## RE: CHARTERS ROAD – STREETSCAPE – T02-2023 -ADDENDUM #3

June 14, 2023

Please note the following questions and answers, clarifications and revisions and revised drawings for the above noted Tender are to be known as Addendum No. 3. The following clarifications, questions and answers, changes, and additions are to apply to all documents, and shall be considered by the bidders in preparing their submissions.

DRAWING TITLE:	PLAN AND PROFILE WATERMAIN STA 2+000 TO STA 2+120
PROJECT TITLE:	CHARTERS ROAD
PROJECT LOCATION:	DISTRICT OF SOOKE

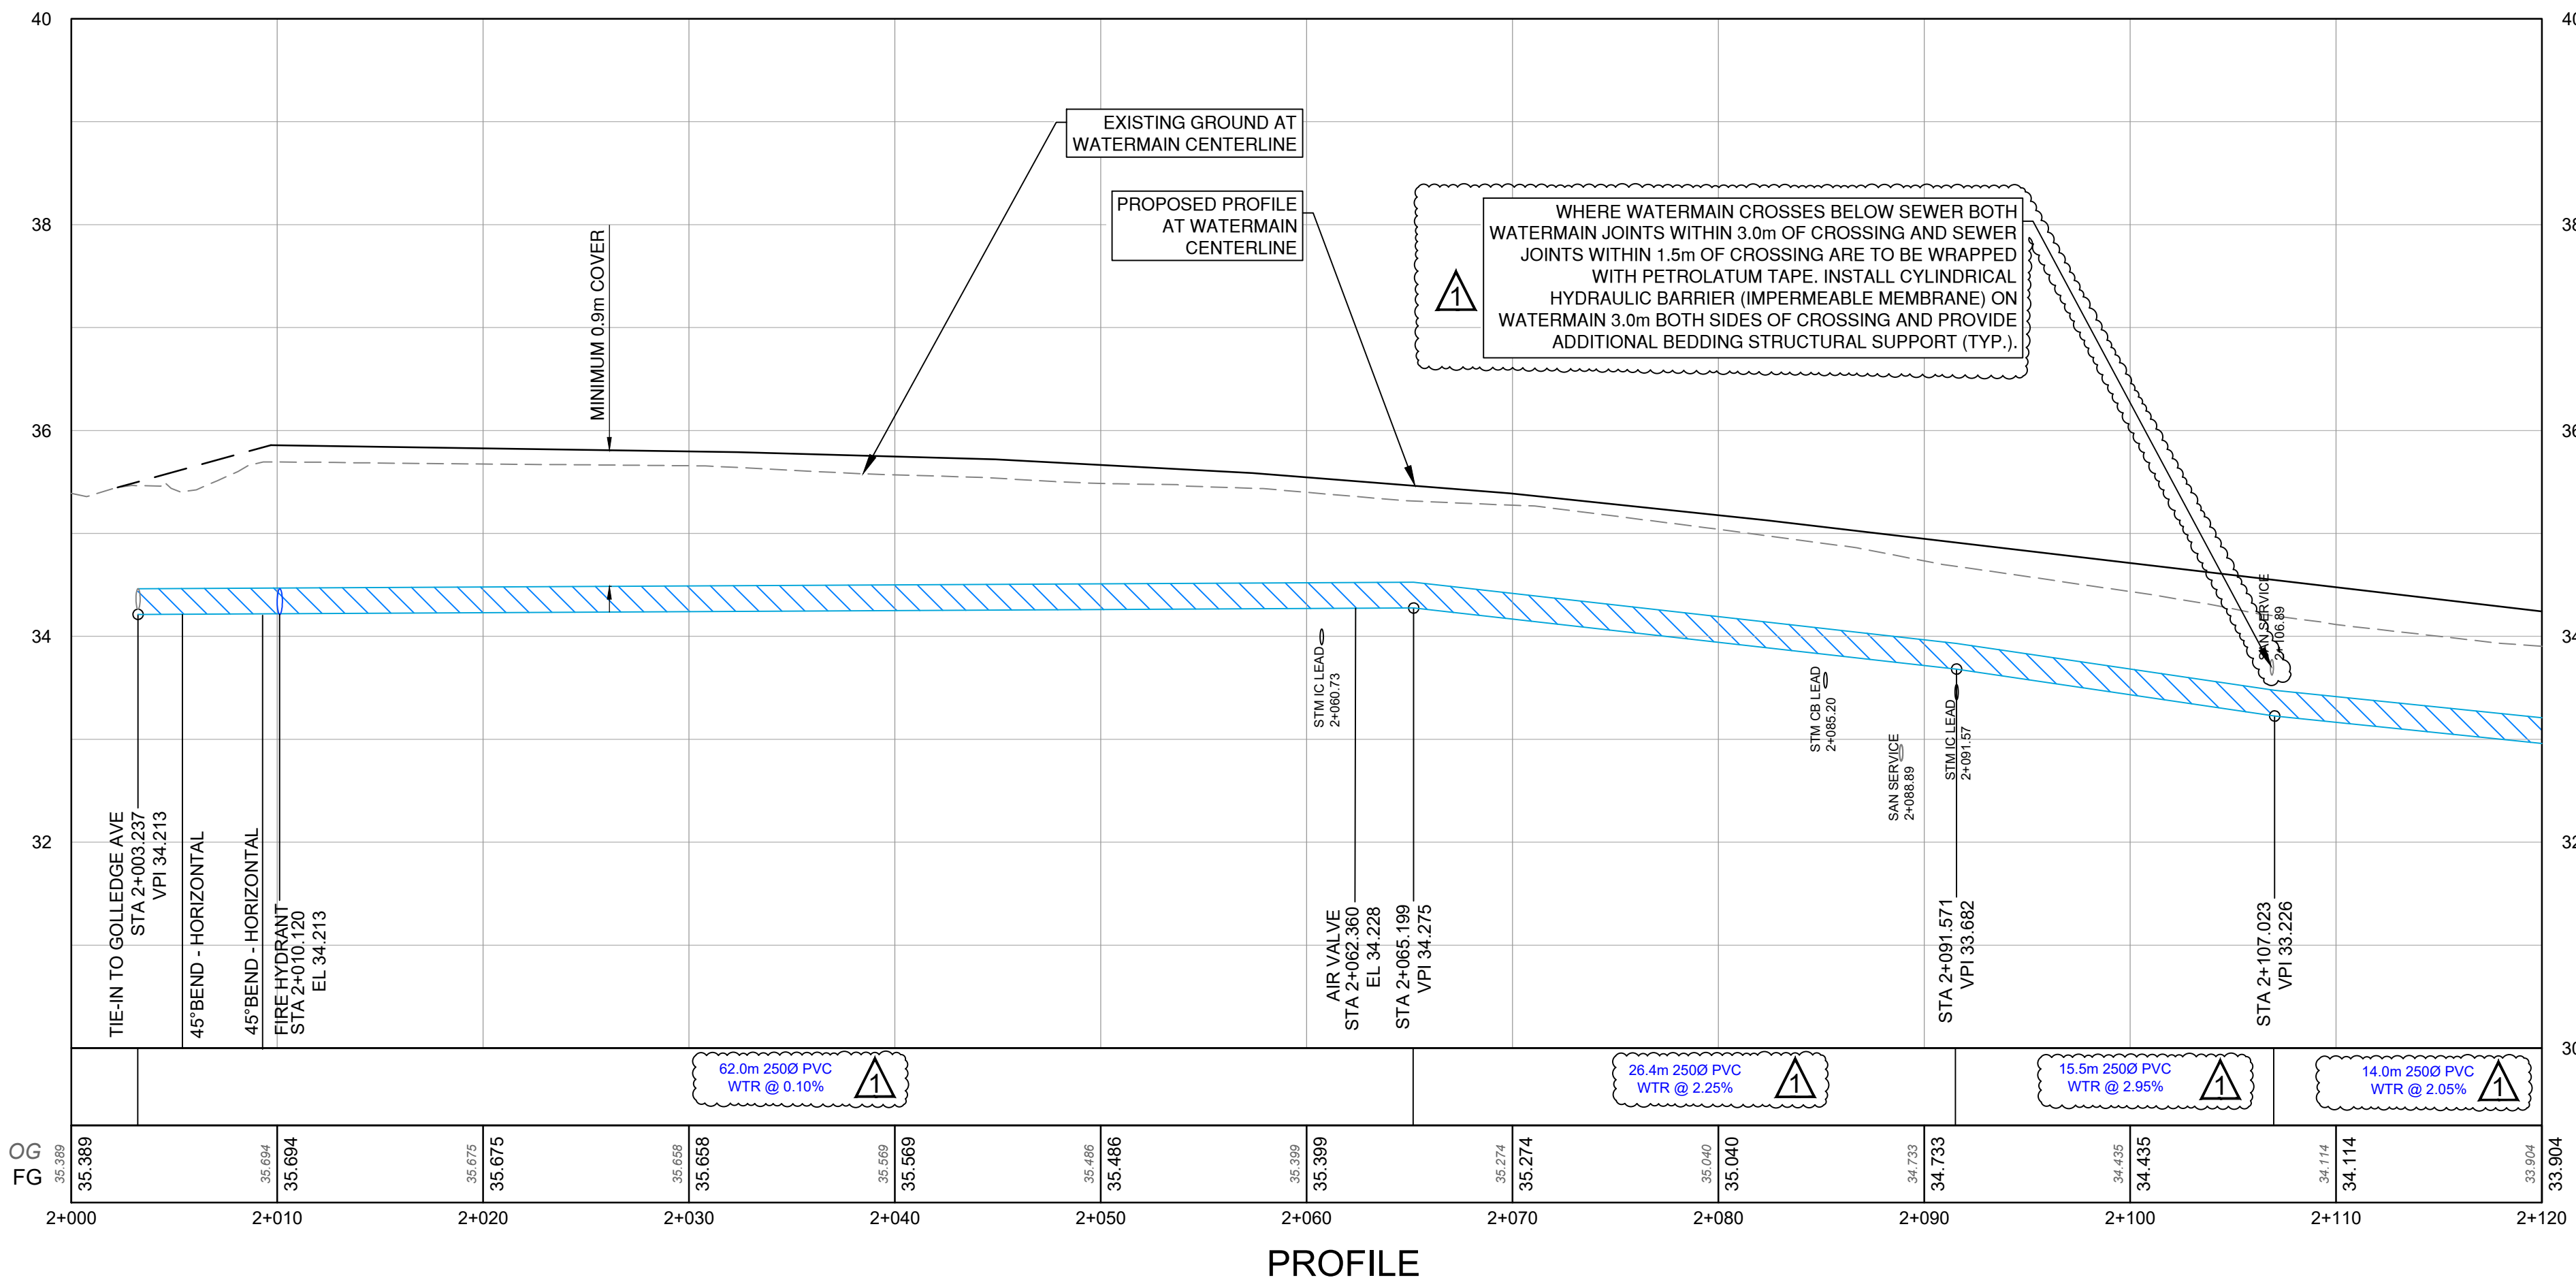
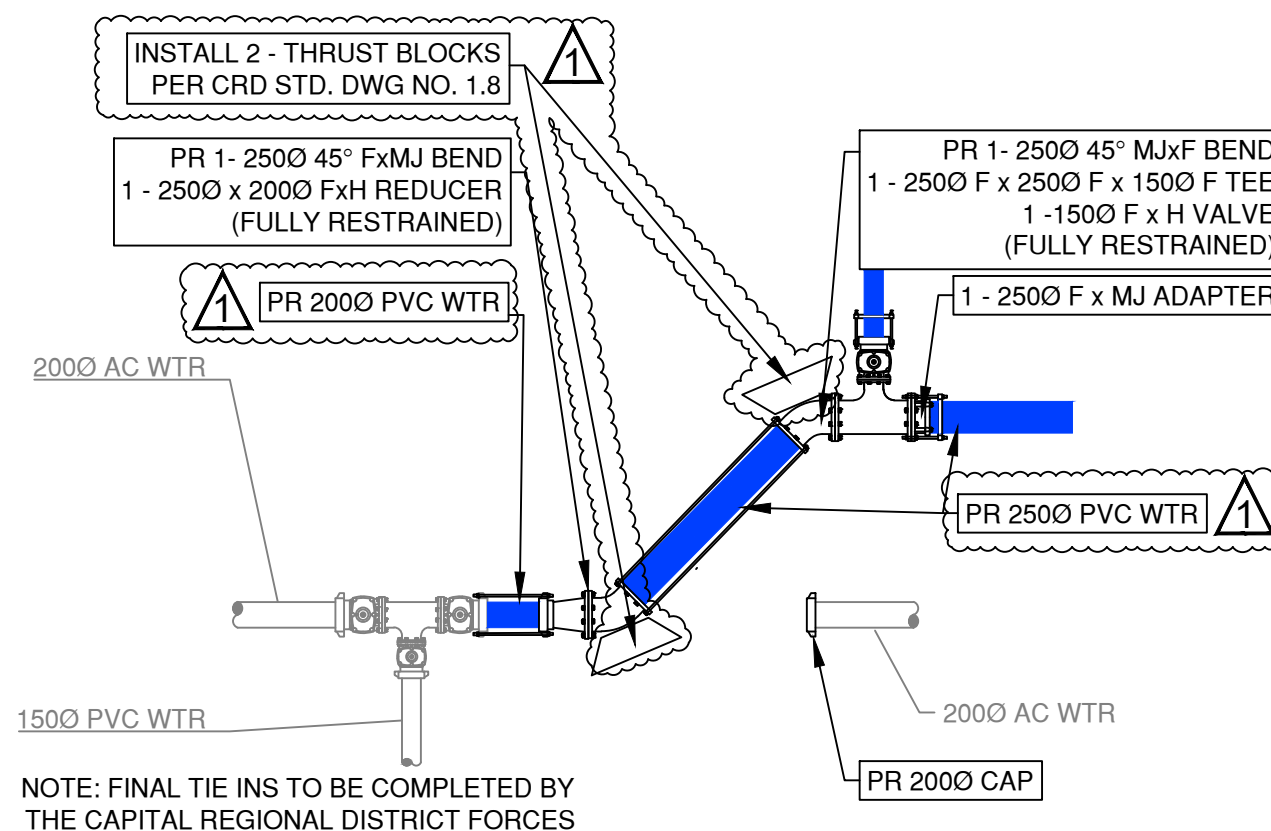
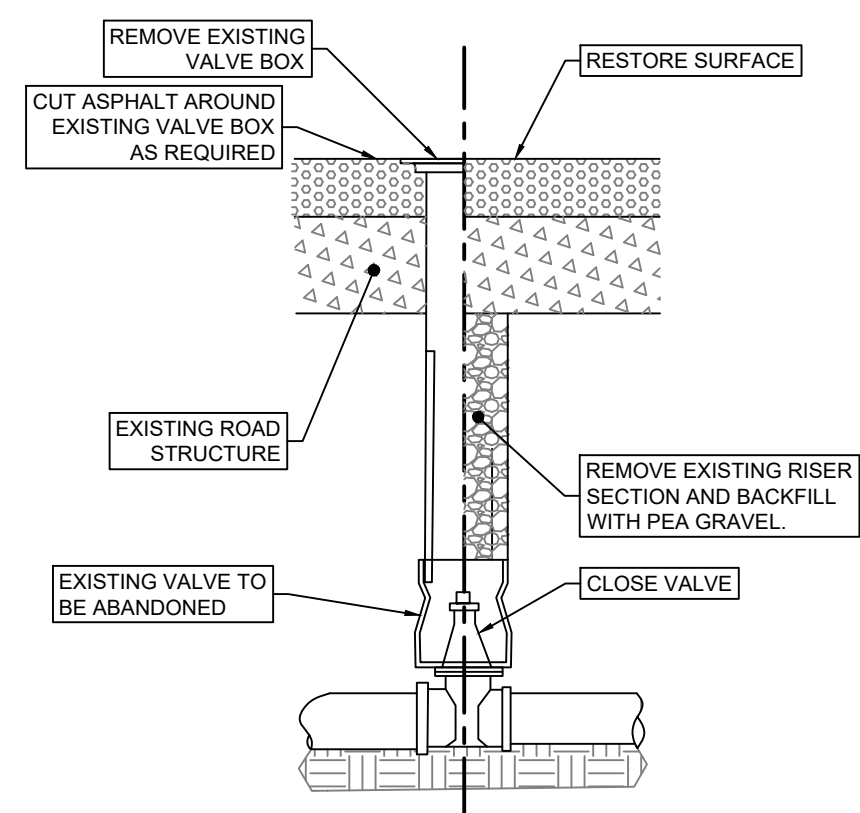
1. The following drawing sheets have been updated with various minor design modifications or note changes for clarification. All changes to the drawings have been identified with a cloud line around the change.

Sheet 14	Revision 1	WATERMAIN STA 2+000 TO STA 2+120
Sheet 15	Revision 1	WATERMAIN STA 2+120 TO STA 2+210
Sheet 16	Revision 1	WATERMAIN STA 2+210 TO STA 2+360
Sheet 17	Revision 1	WATERMAIN STA 2+360 TO STA 2+480
